Staff Report

Floodplain Development Review

FP-08-23

This staff report evaluates a Floodplain Development Review application to replace Bridge 691.7 in the Brooklyn Subdivision. The bridge is located along the Brooklyn Subdivision of Union Pacific Railroad (UPRR) spanning Albany, Oregon. More specifically the site is located where the UPRR track crosses Periwinkle Creek at coordinates 44.637060° North, 123.086354° West (see Attachment A). There are two tracks at this location, but only the southern bridge is owned and scheduled for replacement by UPRR. The bridge serves UPRR's single mainline track running generally in a north-east to south-west direction through the study area. Bridge 691.7 crosses Periwinkle Creek with a drainage area of 6.27 square miles. Approximately 500 feet upstream of Bridge 691.77 is a 12 by 9-foot corrugated metal pipe arch (CMPA) culvert serving Santiam Road SE. The downstream structure is a 12.00-foot corrugated metal pipe (CMP) culvert (not owned by UPRR).

Figure 1. Approximate 100-yr floodplain from Coldwater HEC-RAS model.

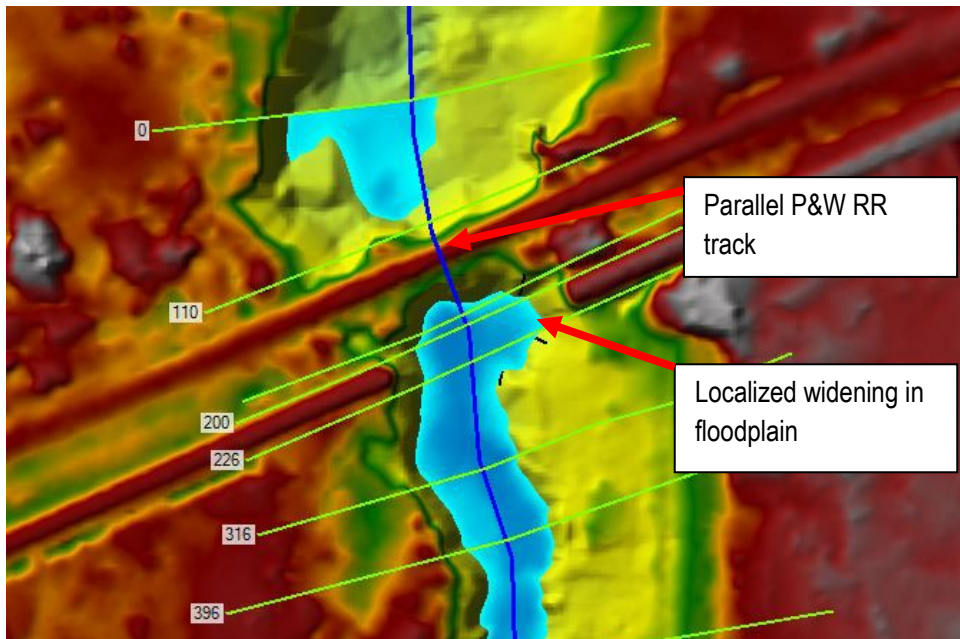
There is a noticeable widening of the 100-yr floodplain at the existing bridge, within the right overbank. The proposed fill would largely be within this locally wider area of the floodplain (Figure 1). Immediately downstream of the subject bridge, flow is confined to a 12' diameter culvert that passes water under the parallel Portland & Western railroad track. A plot of the existing channel cross section (at the proposed bridge location) along with the proposed cross section and upstream cross sections shows that the proposed cross section with fill is similar to the upstream reach (Figure 2).

Based on my review of the floodplain permit materials, the application adequately addresses the floodplain component provisions of 6.100, 6.101(1) & (4), and 6.111 of the City of Albany - Development Code. The Floodplain Permit Review Checklist is shown in Appendix A. Supporting documentation is included in Appendix B.
